Crystal River Unit 3
Docket No. 50-302

April 8, 1996
3F0496-04

Subject: Technical Specification Change Request No. 203, Revision 2, Notifications
Required Prior to MODE 4 and Responses to Request for Additional
Information

VOLTAGE-TO-VOLUME CORRELATION
AND SUPPORTING DATA

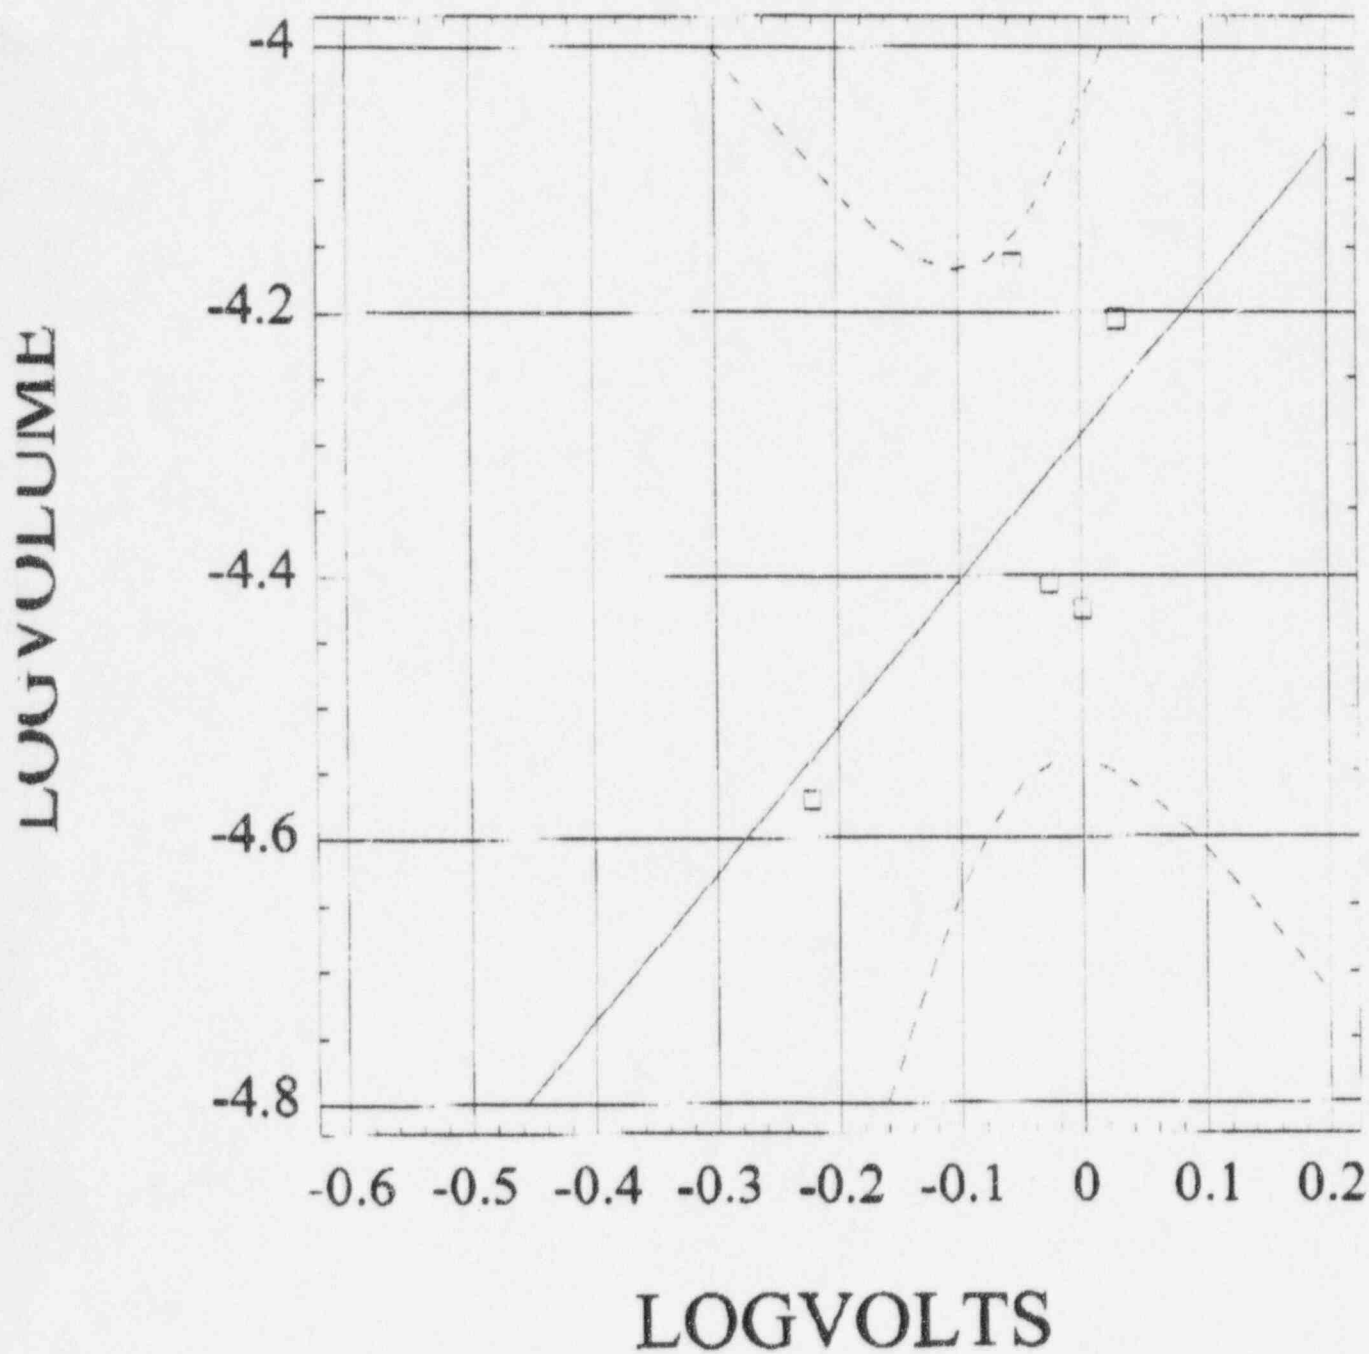
- o Provide a Voltage-to-Volume correlation with wear indications removed from the correlation. The Staff requested a basis for the inclusion of multiple indications in this correlation. Information about the development of the Voltage-to-Volume correlation is provided in Enclosure 1. The information in Enclosure 1 includes the bases for using combined defect volumes as part of the Voltage-to-Volume correlation. Attachment 4 provides the Voltage-to-Volume correlation and the supporting data. Attachment 5 provides data acquisition parameters and variables used in various datasets relevant to this item and to the next item below.

Attachment 4 contains the voltage to volume correlation from Reference 1 with the exception that the data points attributable to wear have been removed. The action to remove the wear data is necessary in order to maintain consistency with the decision to limit the scope of this proposed license amendment to address just first-span, pit-like IGA. The results of the regression analysis of the IGA-only data set support the validity of the 1.25 volt criteria.

Two additional changes to the previous Reference 1 correlation curve data set were necessary as a result of the decision to include only first-span, IGA indications. Firstly, the voltages used in the previous correlation and presented in Reference 2 were based upon a re-analysis of CR-3 pulled tube data normalized using the P1 channel. This was necessary in order to provide comparability of the voltage values for IGA and those associated with wear and justify combining both data sets. The CR-3 P1 channel is a mixed frequency channel which utilizes 600 and 200 kilohertz frequencies. It is utilized in the analysis of tube support plate (TSP) indications where the elimination of the TSP residuals allows better identification and quantification of indication signals. For the same reasons that all previous data was normalized on the P1 channel, it is now necessary to modify the values of signal amplitude (voltages) for each of the IGA indications. In order to provide the most defensible values for voltage, FPC has used the signal amplitude data obtained for those indications from Reference 1 which were detected in the field as part of the pre-tube pull bobbin coil eddy current examination. The decision to utilize pre-pull field ECT data meant that two of the data points were not utilized in the revised correlation. One of the defects was not detected in the field. The other was run twice (initial examination and then later as a 'PID' "Positive Identification") with widely varying results, causing the data point to be suspect. A statistical analysis of the data point also indicated it to be questionable. Thus, this data point was excluded from the final correlation.
